Intersection ID: 44168	Main Street: MEADOW_KNOLL_DR	Cross Street: PRAIRIE_VALLEY_DR	Location:	N
ADA ID: 0D1FC2A40B67	Ramp Type: PerpDiag	Initial Pass/Fail: Fail	Overall Compliance: No	Severity Score: 35

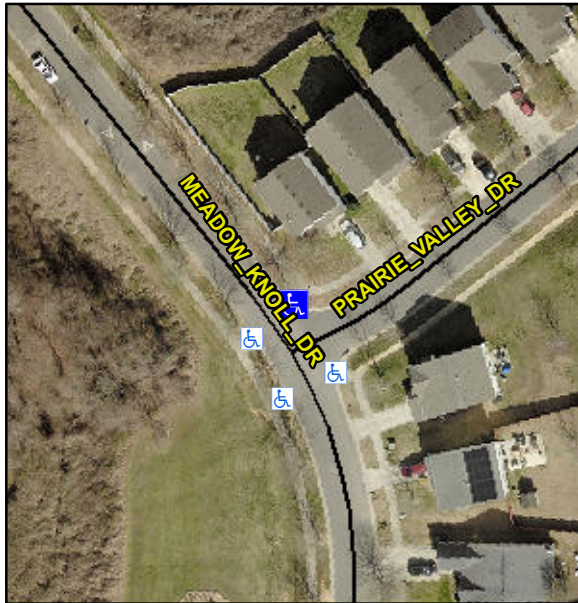
Remove & Replace Curb Ramp With Two New Directional Ramps or Equivalent.

Not Found, R304.5.1

Compliance	Description	Data	Compliance	Description	Data
N/A	Ramp Length (in)	86.5	Yes	Ramp Slope (%)	7.3
No	Ramp Width (in)	27.0	Yes	Ramp XSlope (%)	1.7
N/A	Flare Type LT	N/A	N/A	Flare Type RT	N/A
N/A	Flare Slope LT (%)	N/A	N/A	Flare Slope RT (%)	N/A
N/A	Flare Traversable LT?	N/A	N/A	Flare Traversable RT?	N/A
N/A	Landing Length (in)	N/A	N/A	DWS Provided?	N/A
N/A	Landing Width (in)	N/A	N/A	DWS Contrast?	N/A
N/A	Landing Slope (%)	N/A	N/A	DWS Length (in)	N/A
N/A	Landing X Slope (%)	N/A	N/A	DWS Full Width?	N/A
N/A	Landing Curb? (Y/N)	N/A	N/A	DWS Offset (in)	N/A
N/A	Shared Landing?	N/A			
N/A	Gutter Ponding?	N/A	N/A	Gutter Slope (%)	N/A
N/A	Gutter Lip Ht (in)	N/A	N/A	Gutter X Slope (%)	N/A
N/A	Painted X Walk1?	No	N/A	Painted X Walk2?	No
	X Walk 1 Direction	To SW		X Walk 2 Direction	To SE
N/A	X Walk 1 Width (in)	N/A	N/A	X Walk 2 Width (in)	N/A
	X Walk 1 Slope (%)	2.6		X Walk 2 Slope (%)	2.7
	X Walk 1 X Slope (%)	1.3		X Walk 2 X Slope (%)	1.1
